## BULLETIN

### HT SERIES, INTRAAX TRAILER AIR SUSPENSION QUICK ALIGNMENT GUIDE CHANGE

No: TRAILER AUS - 014  
Subject: *Product Improvement*  
Date: February 1999 Revision: A

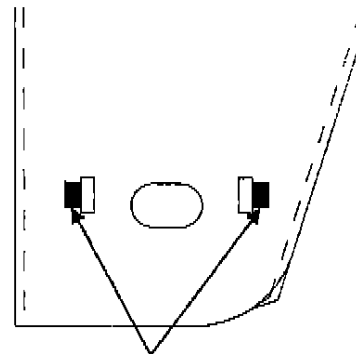
CURRENT VERSION  
Round alignment guide  
with full weld

NEW VERSION  
Two pieces of square  
steel stock

The current alignment, "eyebrow" design is being replaced with key stock material at the maximum alignment positions (10 and 2 o'clock). This new alignment guide reduces the possibility of the QUIK-ALIGN eccentric collar "riding up" on the guide due to improper collar installation.
